FILE: NG-3514(R)

H. B. ROBINSON STEAM ELECTRIC PLANT, UNIT NO. 2
DOCKET NO. 50-261
LICENSE NO. DPR-23
CONTROL OF HEAVY LOADS NEAR SPENT FUEL

Your letter of June 12, 1978, requested information on the physical layout of the Robinson fuel handling areas and on the heavy loads which are handled over spent fuel. Submittal of our responses has been delayed a few days beyond your requested schedule due to in-house workload. We hope that this does not cause you undue inconvenience. Your questions and the Carolina Power & Light Company responses for Robinson Unit No. 2 are listed below:

FIGURE 1

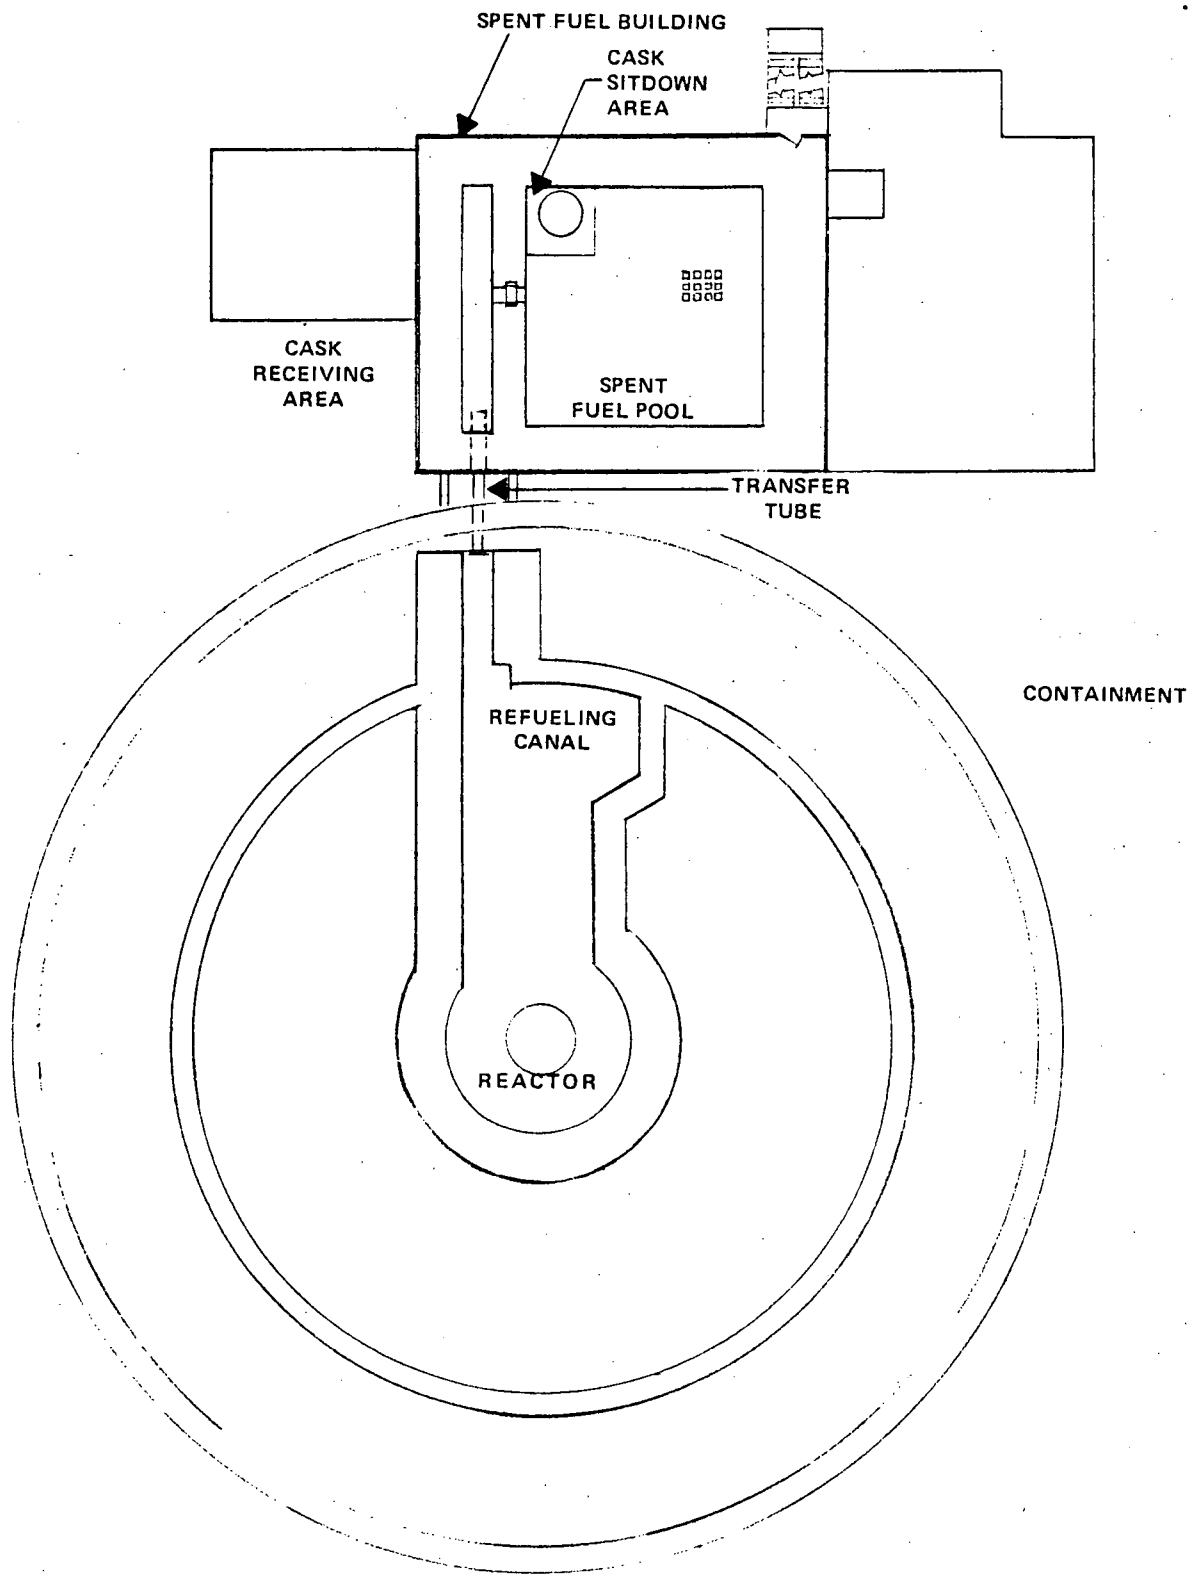
Question 1. Provide a diagram which illustrates the physical relation between the reactor core, the fuel transfer canal, the spent fuel storage pool and the set down, receiving or storage areas for any heavy loads moved on the refueling floor.

Response: Refer to Figure 1 (attached) which is a diagram of the Robinson Unit 2 fuel handling areas.

FIGURE 2

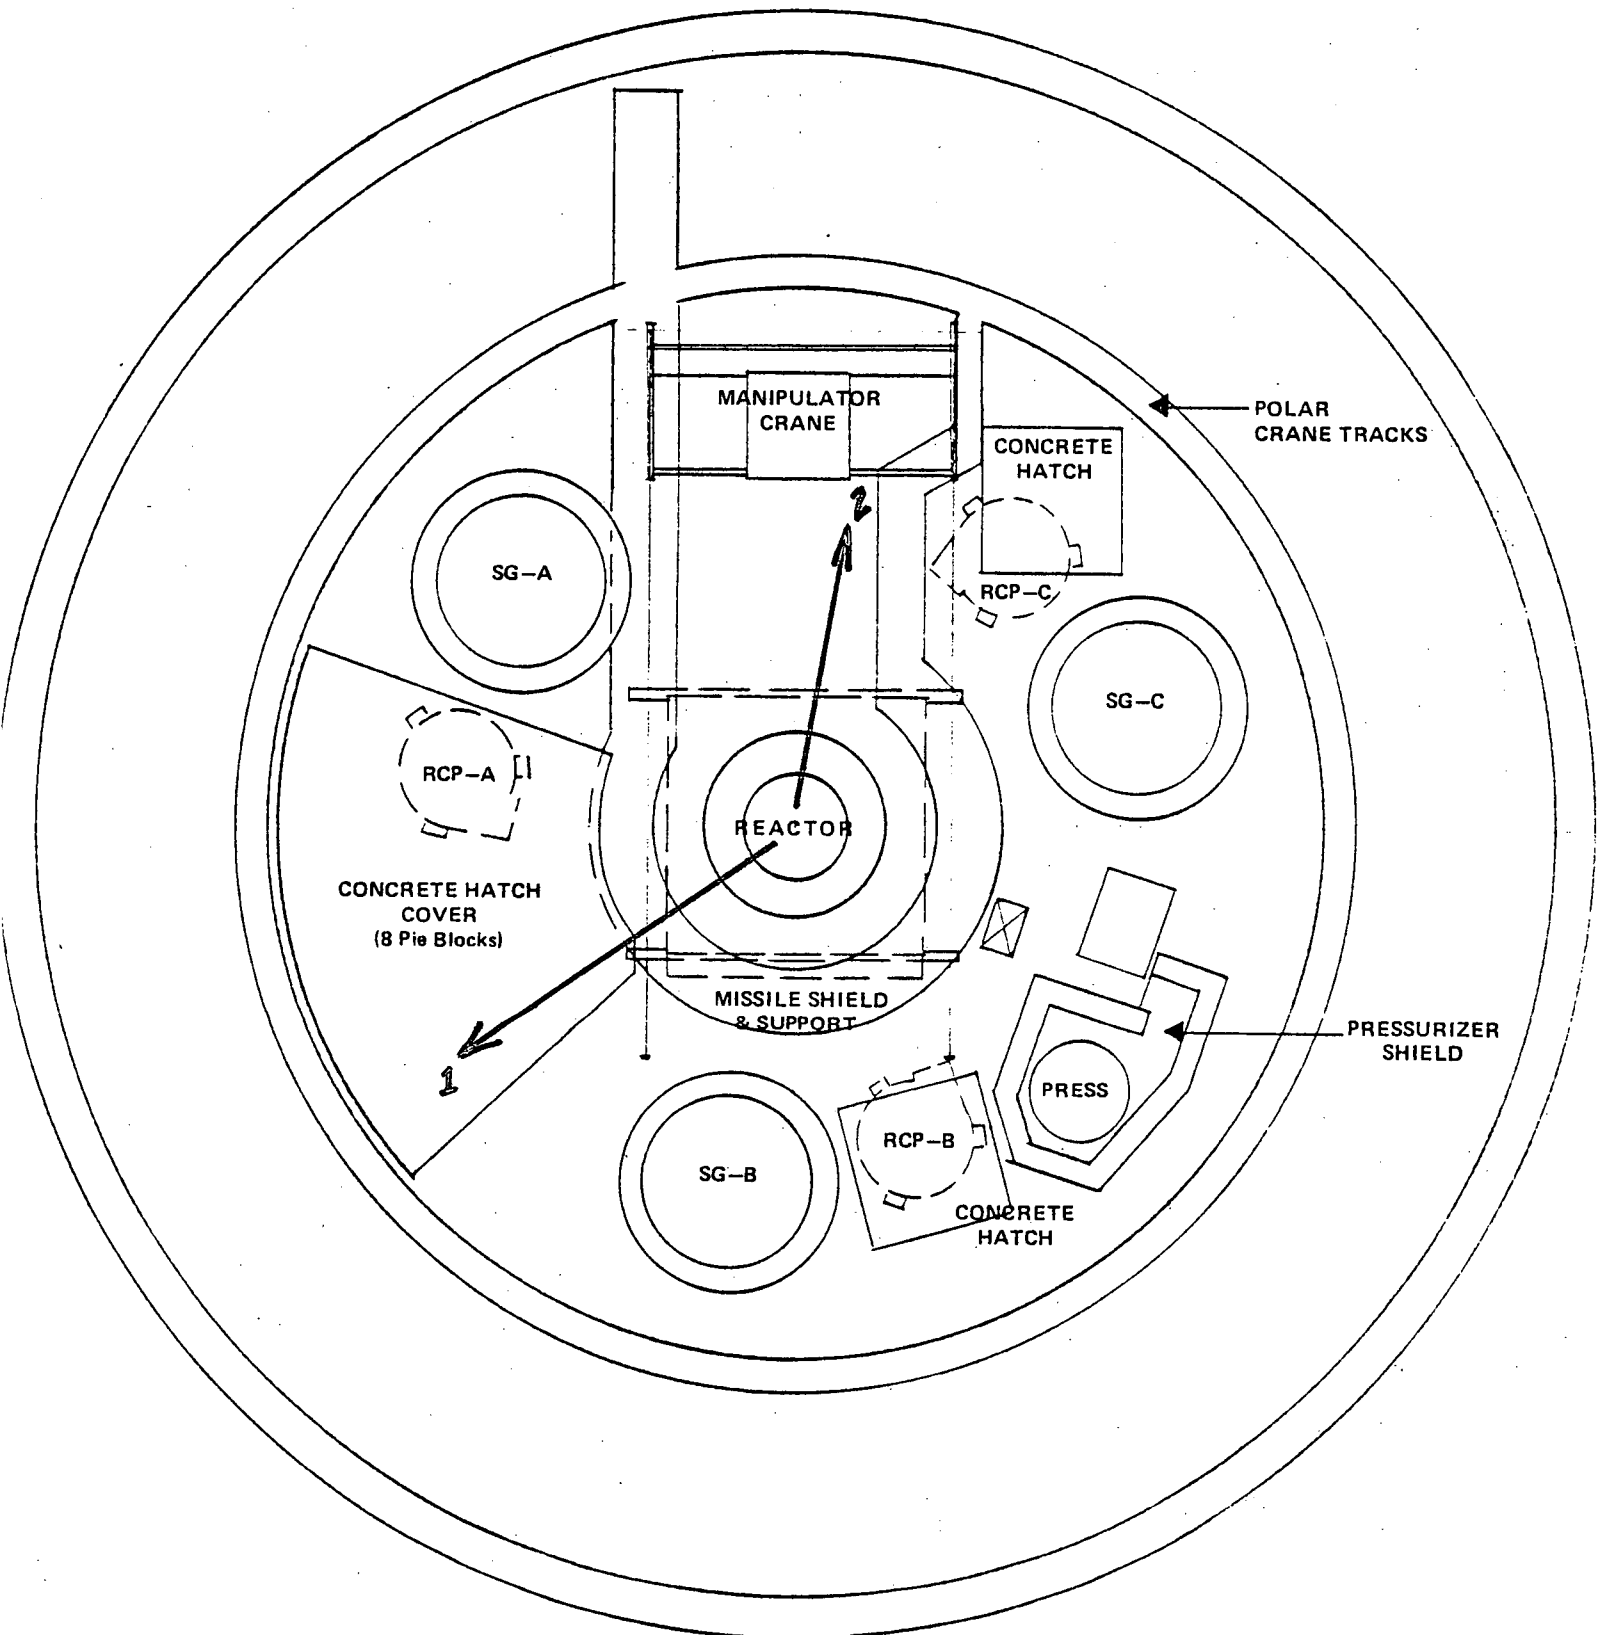
Question 2: Provide a list of all objects that are required to be moved over the reactor core (during refueling), or the spent fuel storage pool. For each object listed, provide its approximate weight and size, a diagram of the movement path utilized (including carrying height) and the frequency of movement.

- A) The reactor vessel head is removed from and returned to the vessel along path 1 as shown in Figure 2 once per refueling.

Weight - Approximately 57 Tons
Dimension - 189 Inches in Diameter
Carrying Height - 30 Feet Above Reactor Core

- B) The reactor upper internals are removed from and returned to the vessel along path 2 as shown in Figure 2 once per refueling.

Weight - 43 Tons
Dimensions - 170 Inches in Diameter, 15 Feet High
Carrying Height - 15 Feet Above Reactor Core
